CLIFDEN TOWN PUBLIC REALM ENHANCEMENT PROJECT INCLUDING
CLIFDEN HARBOUR PARK AND BEACH ROAD QUAY CLIFDEN

STAGE 1 ROAD SAFETY AUDIT

Document Control Sheet	
Document Reference	11252TR01 RSA
Report Status	Issue
Report Date	October 2024
Current Revision	D02
Client:	Galway County Council
Client Address:	County Hall, Prospect Hill, Galway H91 H6KX
Project Number	11252

Figure 2-1 Examples of Discrepancy of Tactile Paving Provisions (Dwg No. 11623_LD_HL_TC_003)

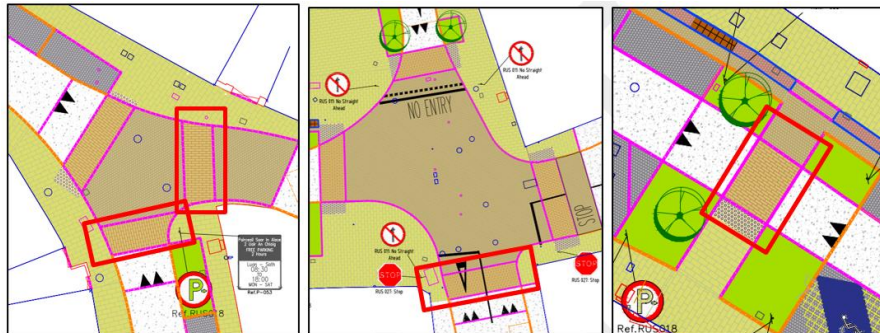
General Item – Tactile Paving

The Audit Team observed on site a number of tactile paving was absent at numerous proposed crossings. The Audit Team are concerned this may result in visually impaired personal will enter the roadway. This may result in a collision between a vulnerable road user (VRU) and a vehicle.

The designer should provide tactile paving at all crossing points throughout the scheme.

Figure 2-2 Examples of Discrepancy Road Markings (Dwg No. 11623_LD_HL_TC_002)

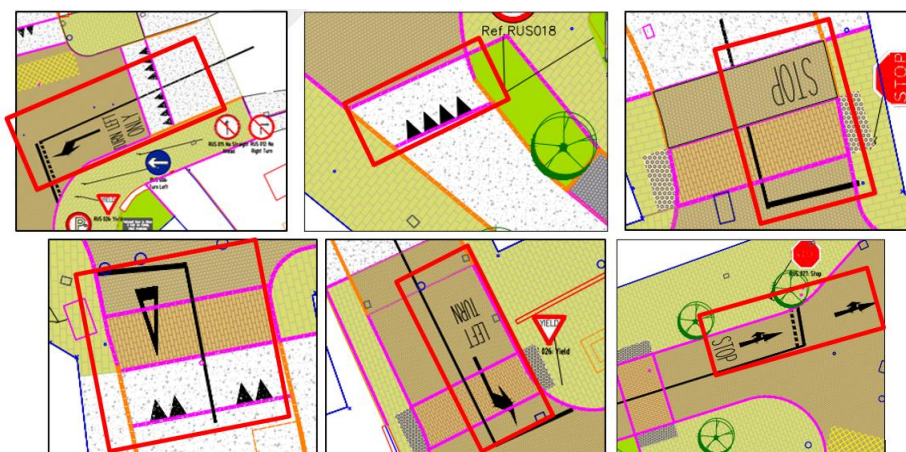
General Item – Road Marking

The Audit Team observed on the design that the proposed road markings are not in accordance with chapter 7 of the Traffic Signs Manual (TSM). The Audit Team are concerned that the Inaccurate Road marking selection and location could result in a false expectation of the upcoming traffic. This may result in collisions between vehicles or increased risk of collisions with VRU.

The Design Team should provide consistent delineation to Chapter 7 of the TSM across the scheme.

Figure 2-3 Examples of Clashes with Existing Utility Chambers and Proposed design (Dwg No. 11623_LD_HL_TC_003)

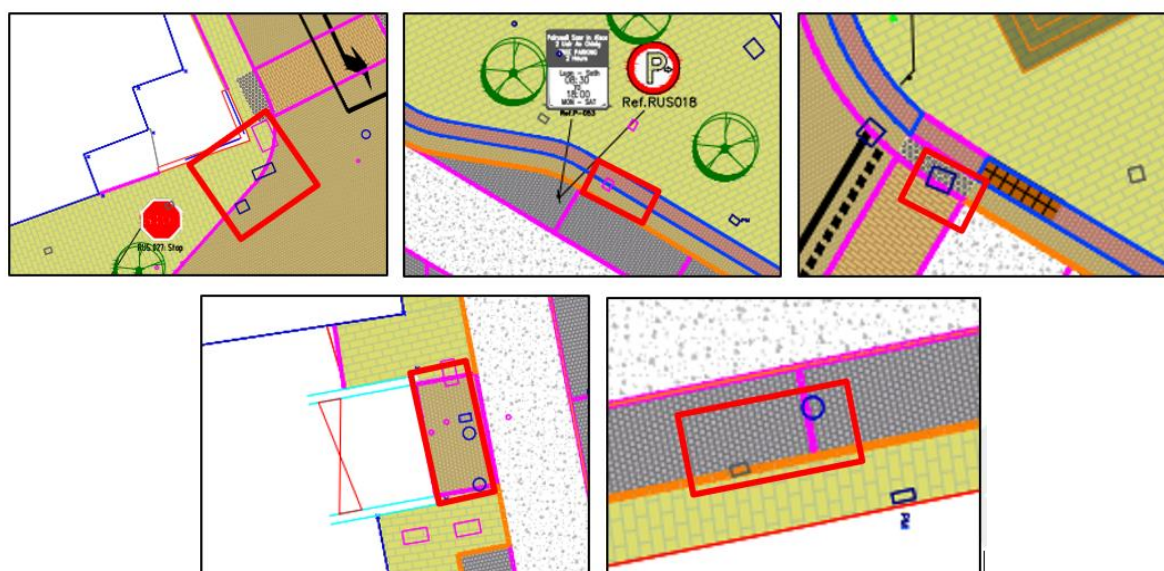
General Item – Existing Utility

The Audit Team observed on site a number of clashes with existing utilities, poles interfacing kerb lines and obstructing footways. The Audit Team are concerned this may result in trip and point of hazards for VRU. This may result in an obstruction for VRU and vehicles.

The designer should divert the existing utilities to remove obstructions for pedestrians and drivers or modify the design to avoid utility clashes.

Figure 2-5 Example of Lack of Tie in Location provided (Dwg No. 11623_LD_HL_TC_002)

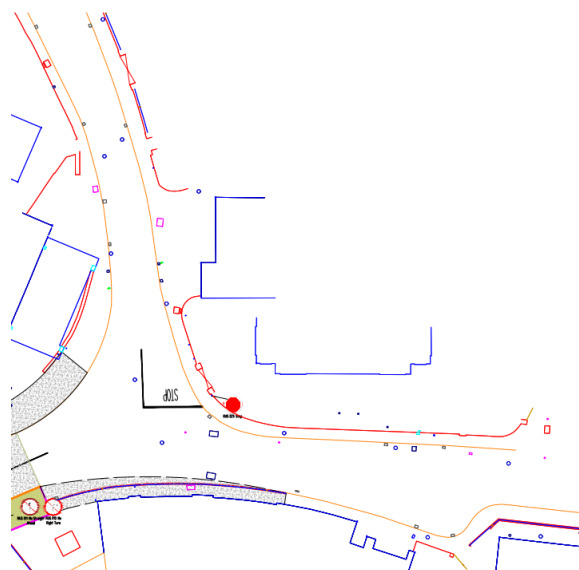
General Item -Lack of Information at Tie in Locations

The Audit team observed on site that a proposed full upstand is shown on the drawings but on the drawings no information on tie in location has been provided. The Audit Team is concerned that an incomplete tie in design may result in drivers' confusion or entry into adjacent facility. This may result in a collision between a VRU and a vehicle.

The design team should ensure that design indicate tie in location.

Figure 2-6 Example of no details of priority at junctions have been provided (Dwg No. 11623_LD_HL_TC_001 & 002)

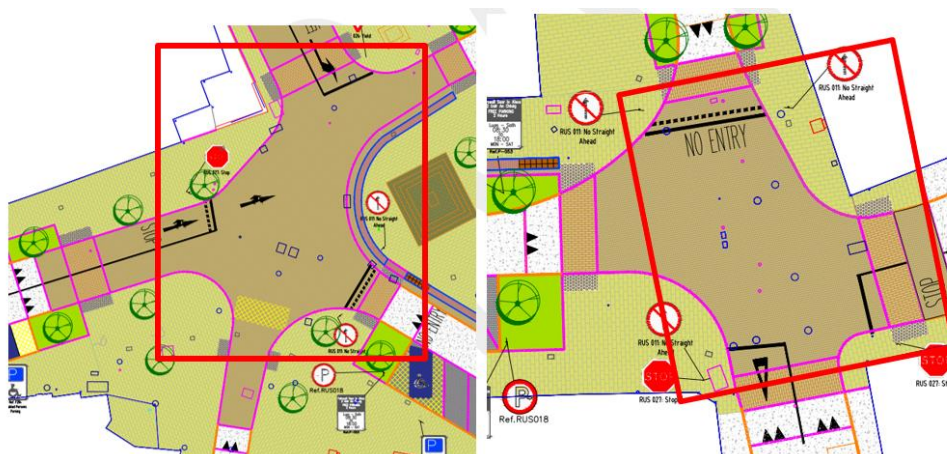
Main Street/ Bridge Street/ Market Street Priority Operation

The Audit Team observed the preliminary design that no details of the operation of the junction have been provided to the Audit Team. The Audit Team are concerned that the lack of clarity on priority of road users could result in driver confusion and turning collisions. This may result in a collision between a VRU and a vehicle.

The designer should show the priority at junctions within the urban area, with clearly defined road marking and signage.

Figure 2-9: No Proposed Cycle Lane termination measure (Dwg No. 11623_LD_HL_TC_001)

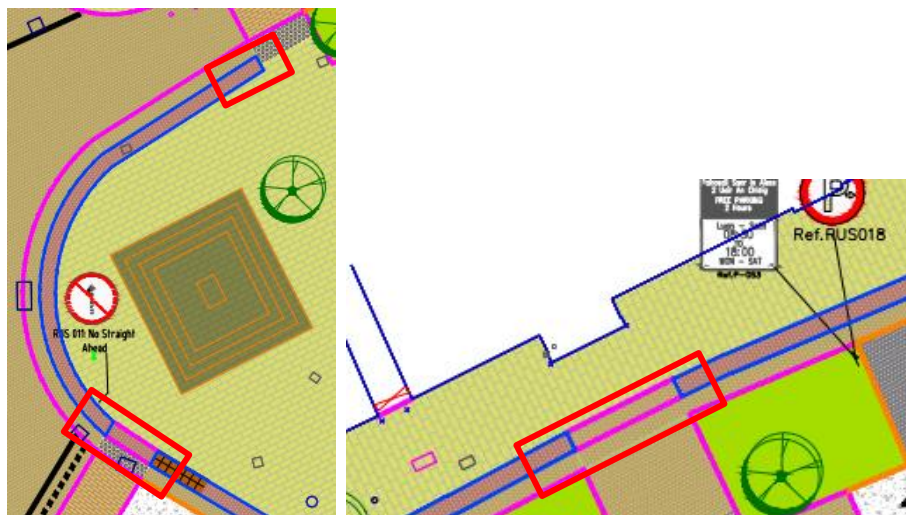
Cycle Lane Termination

The Audit team noted that no transition detail has been provided at the termination of this cycle lane as part of the preliminary design. The Audit Team are concerned that this may give rise to a conflict point between pedestrians and cyclists. This may result in an obstruction for VRU and cyclists.

The design team should ensure the cycle lane is terminated appropriately at the end point.

Figure 2-10: Example of Existing Steps (Dwg No. 11623_LD_HL_TC_001)

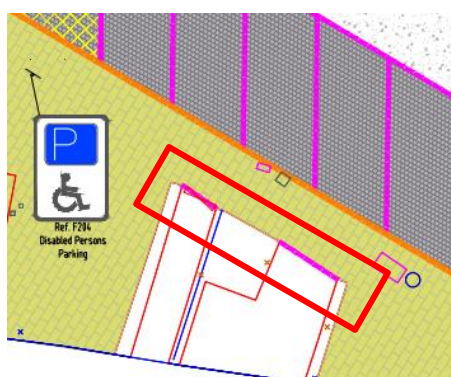
Provision Of Paving at Steps Location

The Audit Team observed the preliminary design proposed paving works and does not include a treatment to provide warning to visually impaired road users. The Audit Team are concerned that this may result in a trip hazard for VRUS. This may result in collisions with visually impaired users and VRUs.

The design team should provide suitable gradients for pedestrians & VRUs across the scheme and ensure protective measures to prevent wheelchair rolling into the carriageway.

Figure 2-13: Existing Upstand Kerb and Parking (Dwg No. 11623_LD_HL_TC_003)

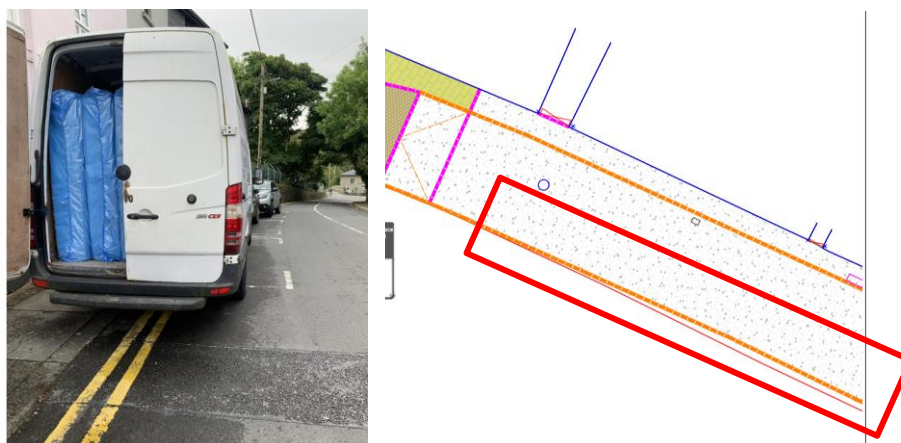
Kerb Type Inconsistency

The Audit Team observed on site that parking facilities have not been provided for this location. The Audit Team are concerned the lack of parking can enforce drivers to park on the footway. This may result in an obstruction to the footway.

The Design team should account for existing kerb type and parking facilities.

Figure 2-18 Bus Bay Road marking and taper (Dwg No. 11623_LD_HL_TC_001)

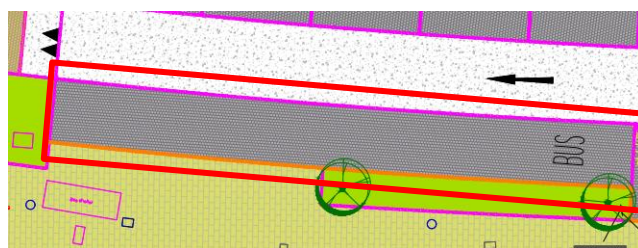
Bus Bay Road Marking and Taper

The Audit team observed on site that no detail on road marking and taper lengths have been provided for the bus bay. The Audit are concerned that the bus will restrict visibility to/from pedestrians who are using the adjacent crossings. This may result in a collision between VRU and a vehicle.

The design team should provide bus bay markings in accordance with the Traffic Signs Manual (TSM).

Beach Road Quay

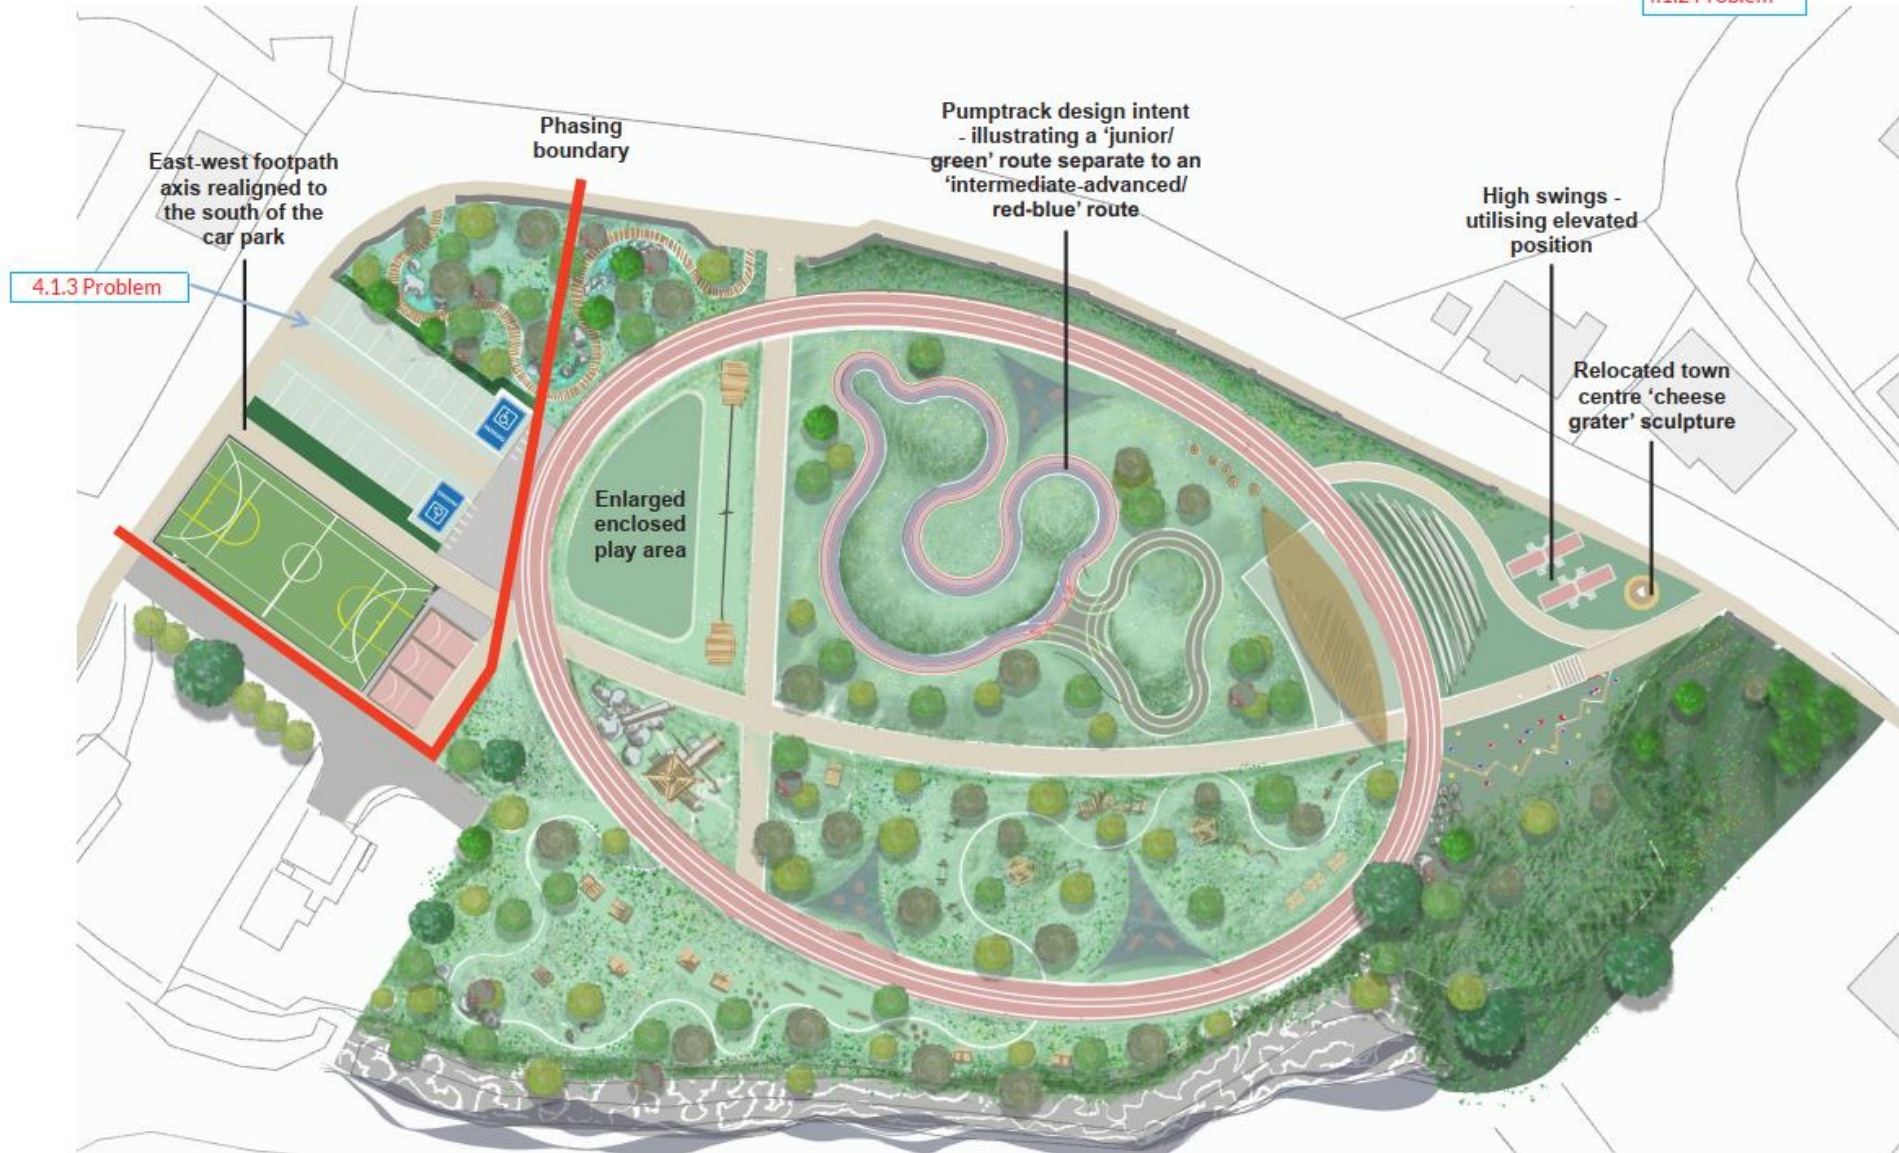
General Items
4.1.1 Problem
4.1.2 Problem

5.1.2 Problem
